AMENDMENTS TO THE DRAWINGS

Attached hereto are two (2) sheets of corrected formal drawings that comply with the provisions of 37 C.F.R. § 1.84. The corrected formal drawings incorporate the following drawing changes:

Fig.4

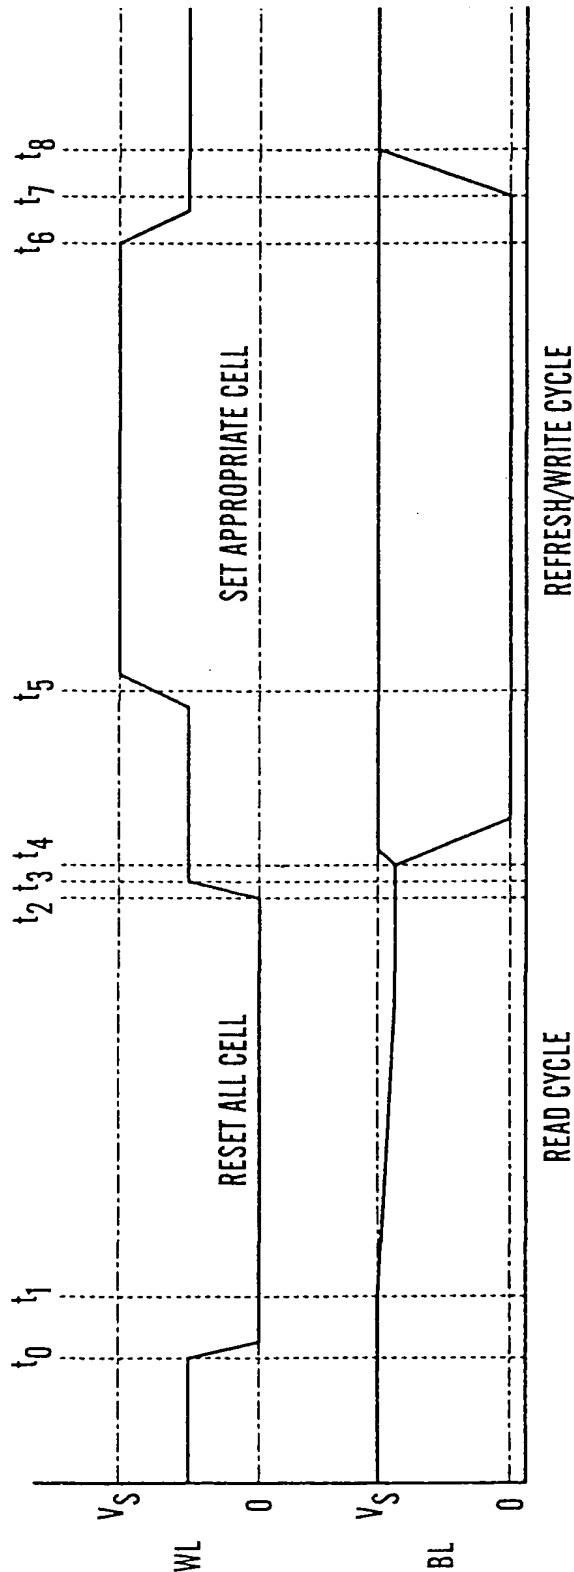
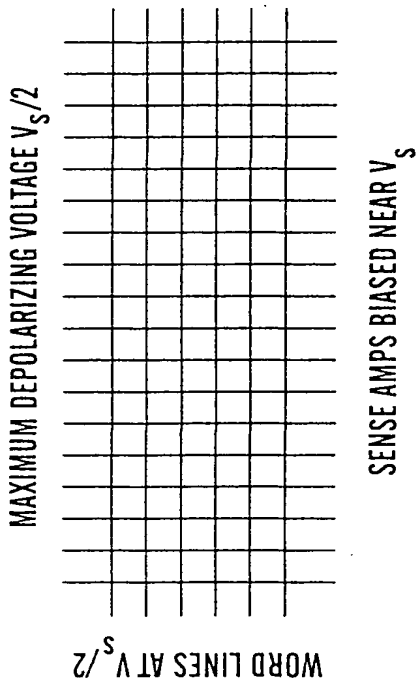
Figs. 4 and 5 – all references to “CAPS” have been amended to read
“CELL”
